PLANNING REPORT

MINISTERIAL REFERRAL

Application number:	TPM-2013-30/C
DELWP Application number:	2013009634-4
Applicant:	88 Queens Bridge Pty Ltd C/- Urbis
Owner:	88 Queens Bridge Pty Ltd & Melbourne Live Pty Ltd
Architect:	Elenberg Fraser
Address:	84-90 Queens Bridge Street & 15-23 Kings Way, SOUTHBANK VIC 3006
Proposal:	<p>Amendment of Ministerial Permit 2013009634-3 under Section 72 of the Planning and Environment Act 1987 by way of</p> <ul style="list-style-type: none"> ▪ Amending the address of the permit. ▪ Amending the design of the development ▪ Amending conditions of the permit
Cost of works:	\$200 Million
Date received by City of Melbourne:	2 October 2020
Responsible officer:	Markus Tschech
Report Date:	22 November 2021
DM# 15045262

Figure 9 - Endorsed (above) and proposed (below) Ground Level Plan. From Drawings TP01.01 & A0100L

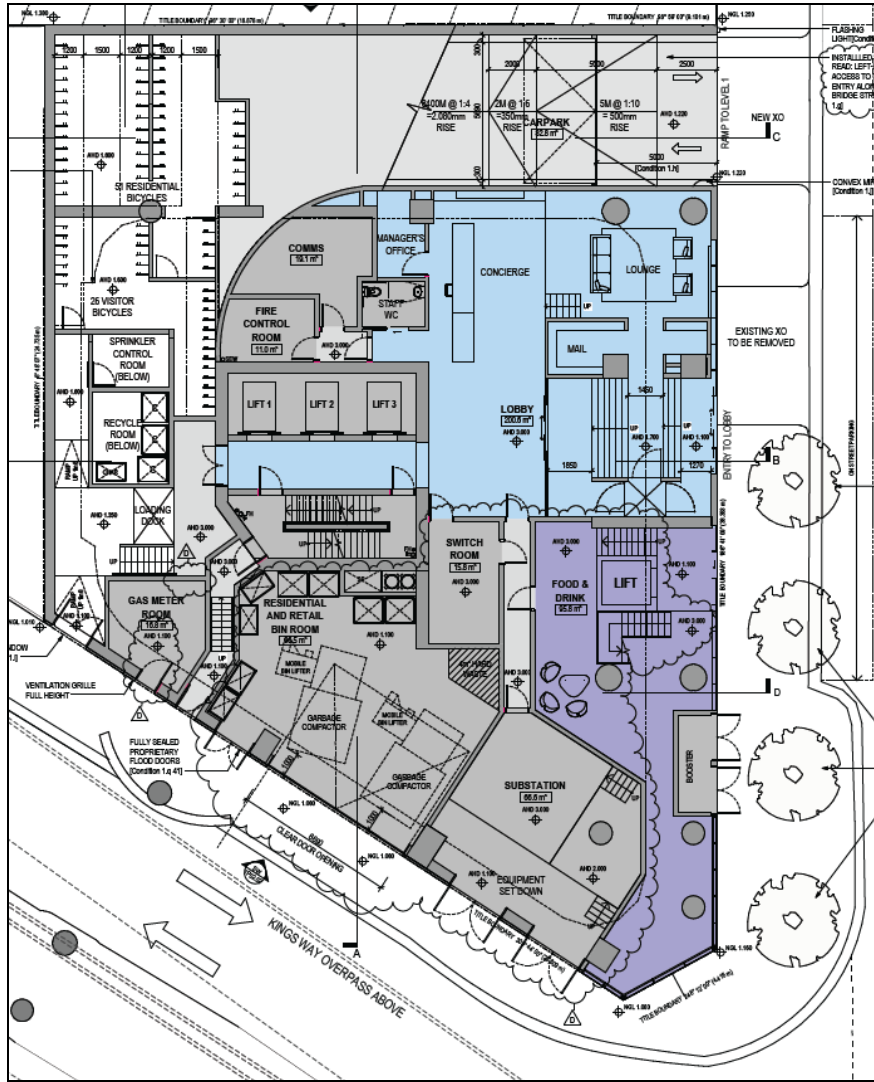
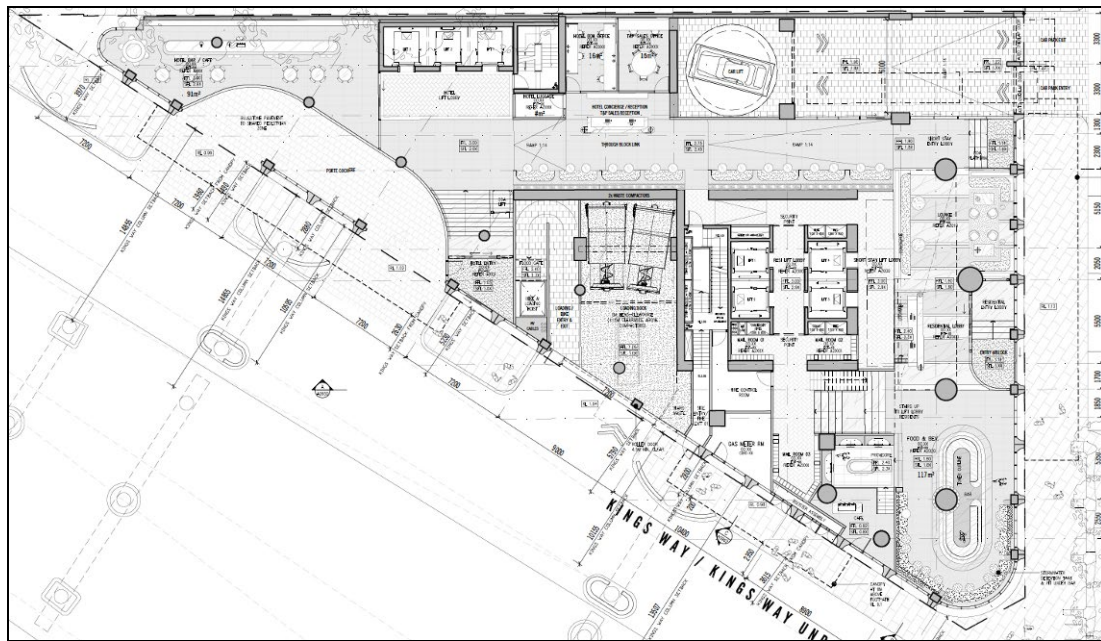
As noted at Section 6.1 of this report, the only concerns raised by Council's Urban Designer at ground level was in relation to the design of the porte-cochere. Based on a substantial amount of time negotiating an improved design, Council's Urban Designer is now satisfied with all aspects of the revised ground level.

Figure 14 - Endorsed Queens Bridge Street elevation extract. From Drawing TP02.07

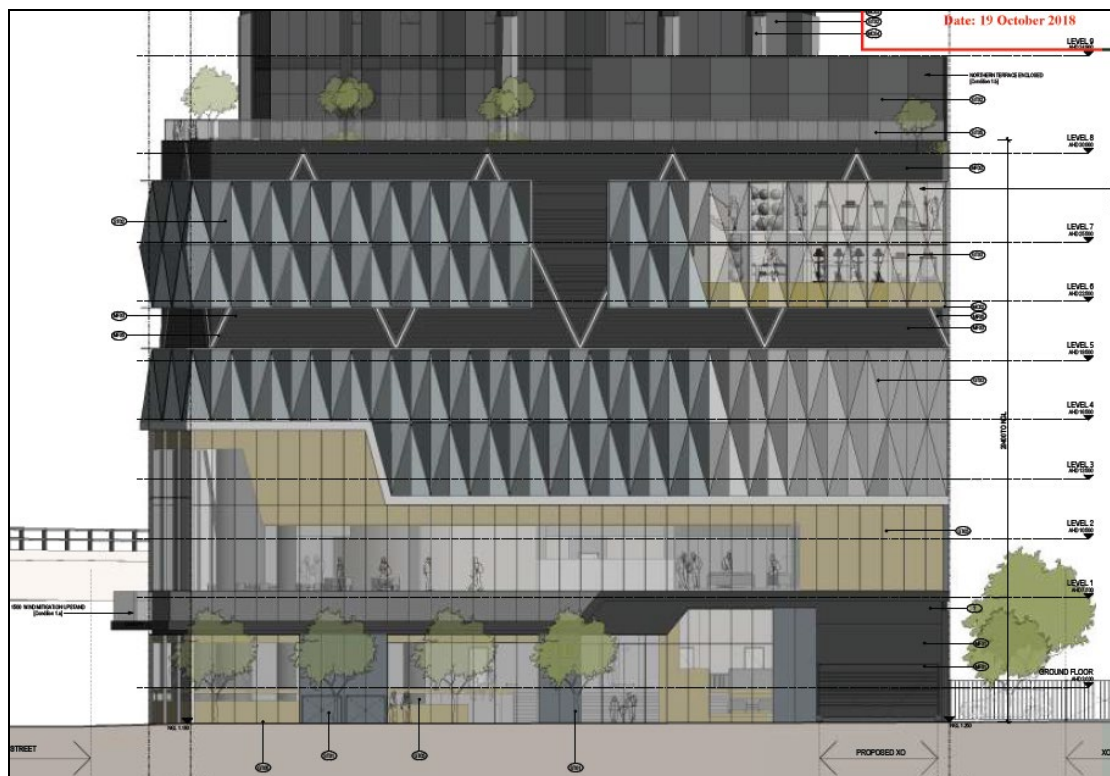
The approved design, as depicted in Figure 14 below, includes an apartment lobby and food and drink premises at ground level. The podium interface is, however, characterised primarily by a patterned wall concealing an above ground carpark.

Although the amended design would maintain above ground carparking, it would be sleeved by hotel rooms across levels 1-8 along both street frontages. At ground level, the amended design removes all services along Queens Bridge Street, and includes separate residential and hotel entries, in addition to a redesigned and larger food and drinks premises.

The amended design also presents a more refined architectural response, with a grid pattern of black/bronze metal framed windows replacing broad expanses of curtain-wall glazing and monotone metal cladding.

Figure 18 – Proposed Section showing the use of the top 20 metres of the tower

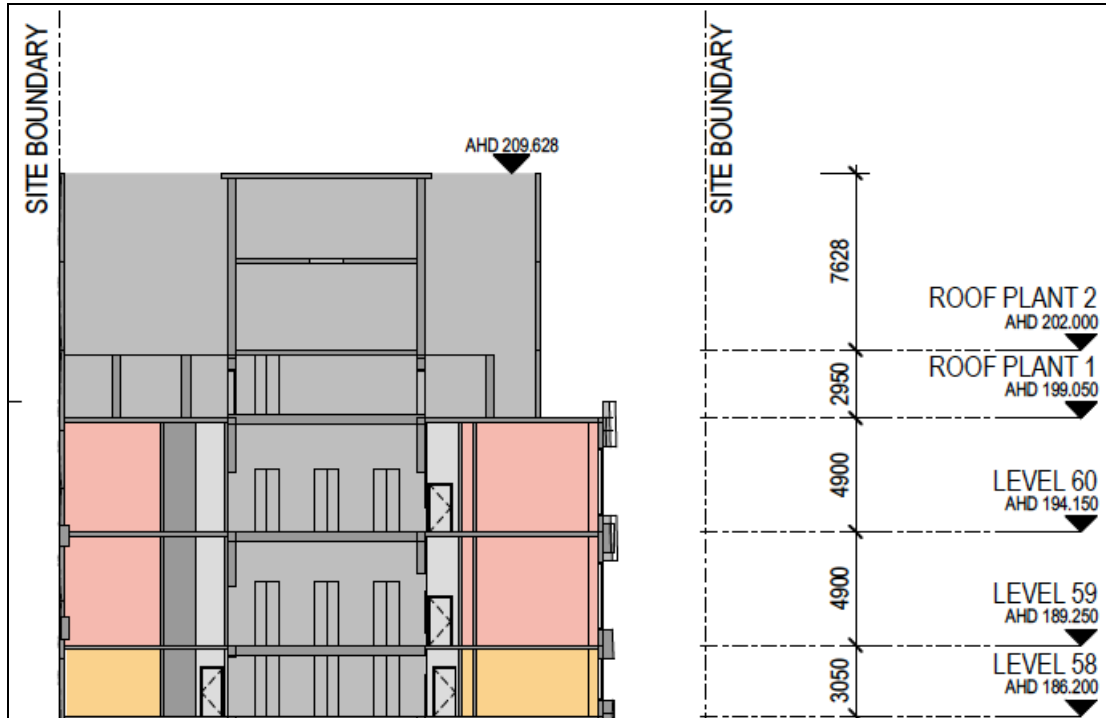
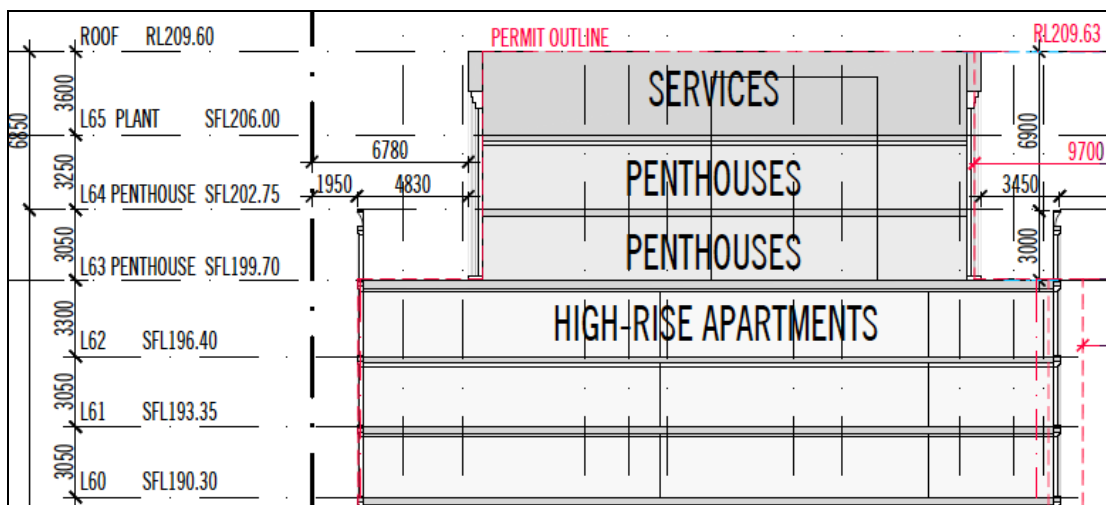
The proposal seeks to increase the number of storeys from 60 to 65 without varying the maximum height (to the top of building services) of AHD 209.63 metres (208.4 metres above natural ground level).

This has been achieved through the reduction in some floor-to-floor heights and substantial reduction in extent of rooftop services, as illustrated in Figures 17 and 18.

Figure 23 - Extract from the RWDI Wind Report illustrating expected wind conditions

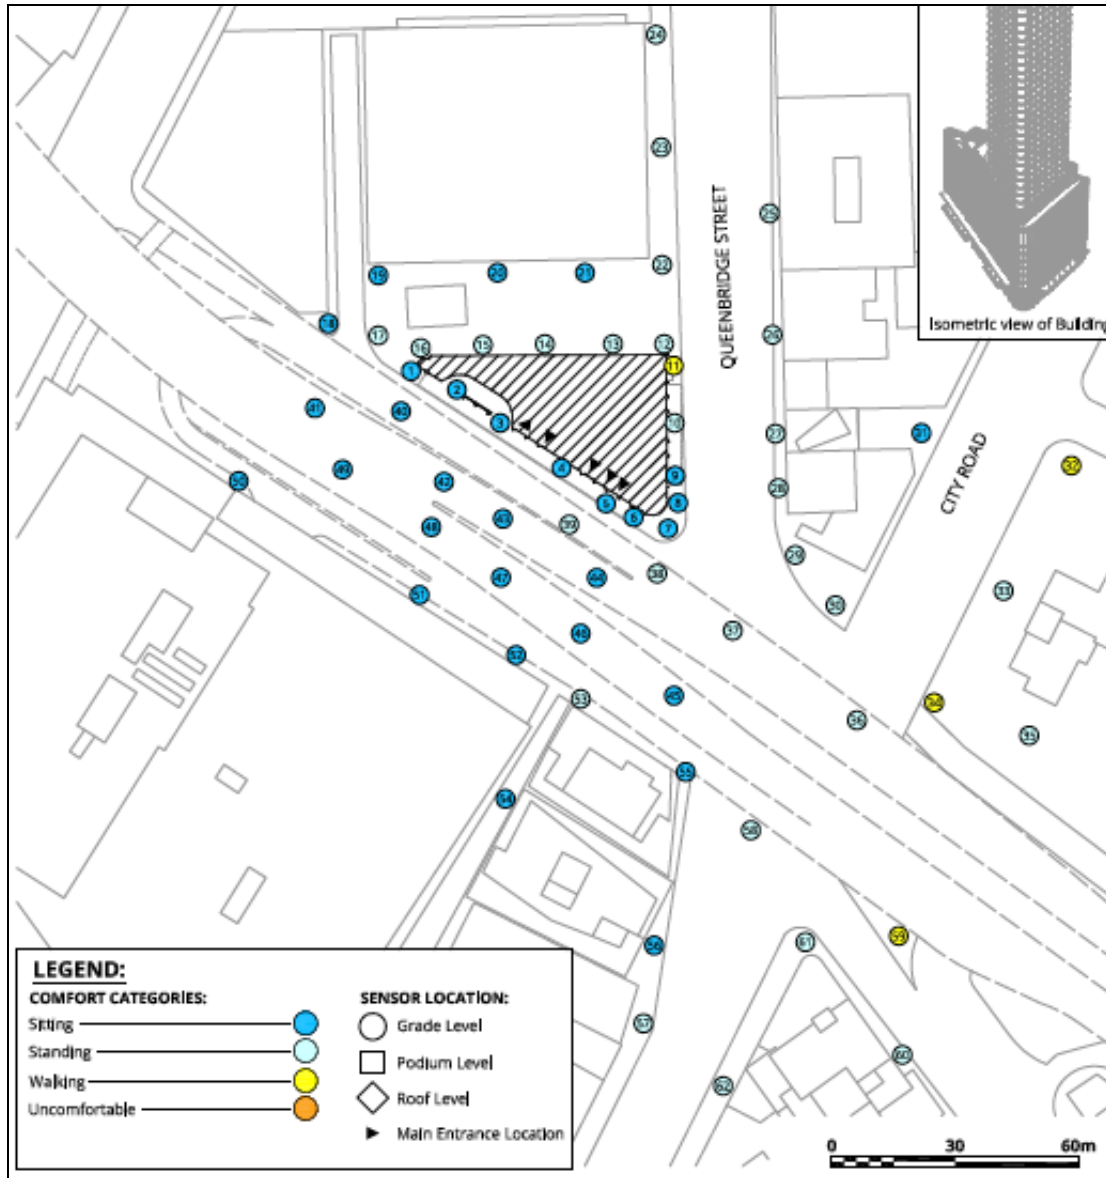
A review of the above results indicates that the only public area which would not achieve at least the standing criterion, is the driveway to the car stacker, which is considered appropriate. It also does not recommend any changes to the architectural drawings to achieve these wind comfort levels.

Figure 24 - Shadow Diagrams depicting the approved (left) and proposed (right) extent of overshadowing

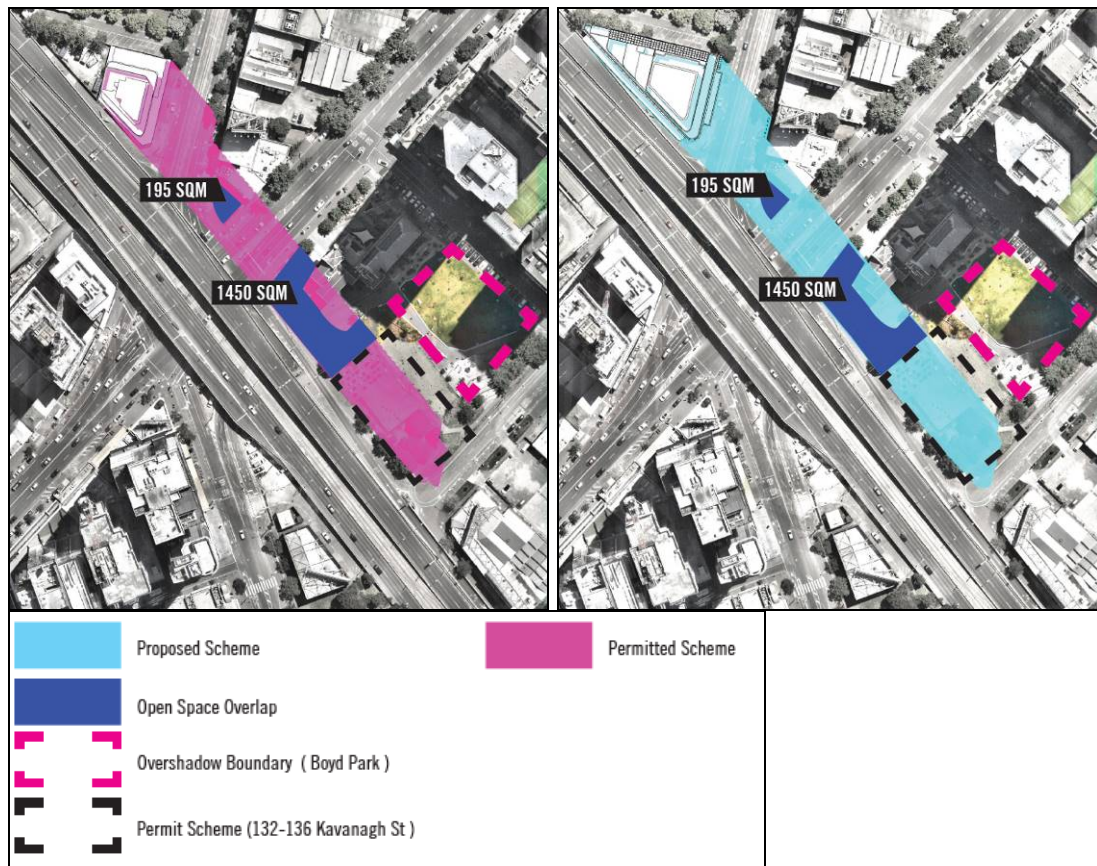
As depicted in the submitted shadow diagrams, the main difference in shadow impact is a result of the expanded podium. The amended development would cast a greater shadow over the surrounding road network, though would not alter the approved extent of shadow over nearby parks, including Boyd Park. To that end, it is noted that the building's (approved and proposed) shadow does not reach the identified section of Boyd Park until after 2pm on the Equinox.

The amended development therefore complies with the mandatory overshadowing requirements of DDO10.
